TOWN OF HORIZON CITY
Planning and Zoning Commission Staff Report

Case No.: **SDP25-0006 Verdancia Unit 4 Preliminary Phase 1**
SDP25-0007 Verdancia Unit 4 Preliminary Phase 2

Application Type: **Preliminary Plat**

P&Z Hearing Date: January 19, 2026

**PROPOSED TYPICAL 54' ROW STREET SECTION DETAIL
(RESIDENTIAL SUB-COLLECTOR)**

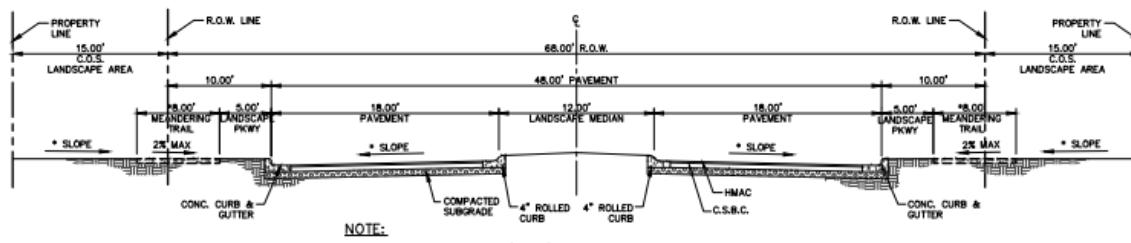
1. Modification from a 52-ft residential sub-collector street right-of-way to a 54-ft street right-of-way at all local residential sub-collector streets. The 54-ft street right-of-way will consist of two 5-ft parkways, two 5-ft wide concrete sidewalks and a 34-ft wide pavement structure with curb & gutter.

1. Modification from a 52-ft residential sub-collector street right-of-way to a 54-ft street right-of-way at all local residential sub-collector streets. The 54-ft street right-of-way will consist of two 5-ft parkways, two 5-ft wide concrete sidewalks and a 34-ft wide pavement structure with curb & gutter.

**PROPOSED TYPICAL 68' ROW STREET SECTION DETAIL @ ENHANCED ENTRANCE
(DUNE FLOWER PARKWAY RESIDENTIAL COLLECTOR)**

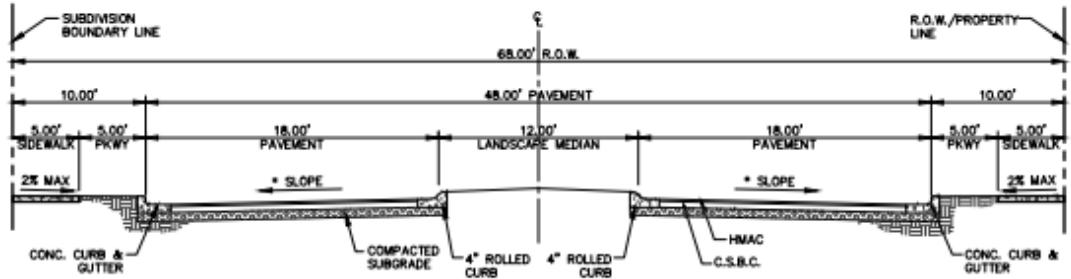
2. Modification to use a 68-ft residential collector at enhanced neighborhood entrances. The 68-foot street right-of-way will consist of two 5-ft parkways, two 5-ft wide concrete sidewalks, two 18-ft wide pavement structures and a 12-ft raised landscape median with curbs & gutter. Landscape areas will be maintained by the HOA.

2. Modification to use a 68-ft residential collector at enhanced neighborhood entrances. The 68-foot street right-of-way will consist of two 5-ft parkways, two 5-ft wide concrete sidewalks, two 18-ft wide pavement structures and a 12-ft raised landscape median with curbs & gutter. Landscape areas will be maintained by the HOA.

**PROPOSED TYPICAL 68' ROW STREET SECTION DETAIL @ ENHANCED ENTRANCE
(DESERT MIST DRIVE RESIDENTIAL COLLECTOR)**

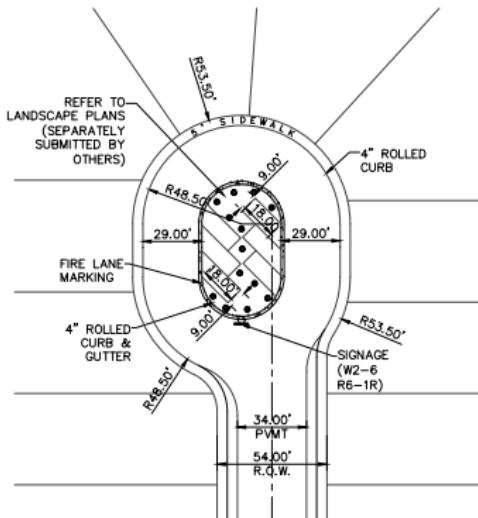
3. Modification to use a 68-ft residential collector with meandering trails at enhanced neighborhood entrances abutting common open space lots. The 68-ft street right-of-way will consist of two 5-ft parkways, 36-ft wide pavement structure with curb & gutter, a 12-ft raised landscape median and two 8-ft wide meandering trails. The 8-ft trails will meander within the street right-of-way parkway area and the adjacent 15-ft common open space landscape lot. This will provide a visually appealing and safe walking trail along this corridor. Landscape areas will be maintained by the HOA.

3. Modification to use a 68-ft residential collector with meandering trails at enhanced neighborhood entrances abutting common open space lots. The 68-ft street right-of-way will consist of two 5-ft parkways, 36-ft wide pavement structure with curb & gutter, a 12-ft raised landscape median and two 8-ft wide meandering trails. The 8-ft trails will meander within the street right-of-way parkway area and the adjacent 15-ft common open space landscape lot. This will provide a visually appealing and safe walking trail along this corridor. Landscape areas will be maintained by the HOA.

TYPICAL CUL-DE-SAC PARKING LAYOUT

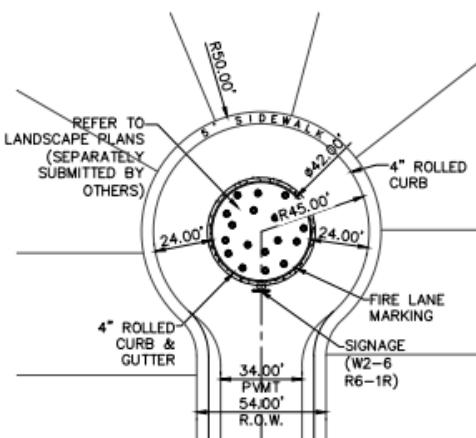
5. Variance from a 50-foot radius Cul-de-Sac street to a 53 ½ -foot radius cul-de-sac with interior parking/landscape islands and outside travel lane roadway width of 29-feet. The proposed cul-de-sac and parking/landscape islands will enhance the neighborhood character, reduce the impervious surface, aid to eliminate typical cul-de-sac "stack" parking while maintaining adequate room for emergency vehicle turning movement. Landscape areas will be maintained by the HOA.

5. Variance from a 50-foot radius Cul-de-Sac street to a 53 1/2 -foot radius cul-de-sac with interior parking/landscape islands and outside travel lane roadway width of 29-feet. The proposed cul-de-sac and parking/landscape islands will enhance the neighborhood character, reduce the impervious surface, aid to eliminate typical cul-de-sac "stack" parking while maintaining adequate room for emergency vehicle turning movement. Landscape areas will be maintained by the HOA.

PROPOSED TYPICAL 54' ROW STREET SECTION DETAIL
(RESIDENTIAL SUB-COLLECTOR)
SCALE: N.T.S.

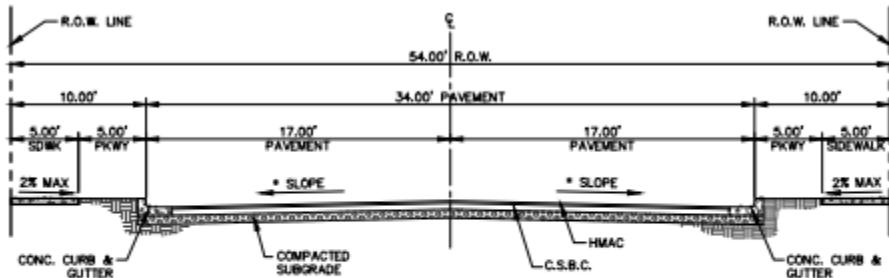
1. Modification from a 52-ft residential sub-collector street right-of-way to a 54-ft street right-of-way at all local residential sub-collector streets. The 54-ft street right-of-way will consist of two 5-ft parkways, two 5-ft wide concrete sidewalks and a 34-ft wide pavement structure with curb & gutter.

1. Modification from a 52-ft residential sub-collector street right-of-way to a 54-ft street right-of-way at all local residential sub-collector streets. The 54-ft street right-of-way will consist of two 5-ft parkways, two 5-ft wide concrete sidewalks and a 34-ft wide pavement structure with curb & gutter.
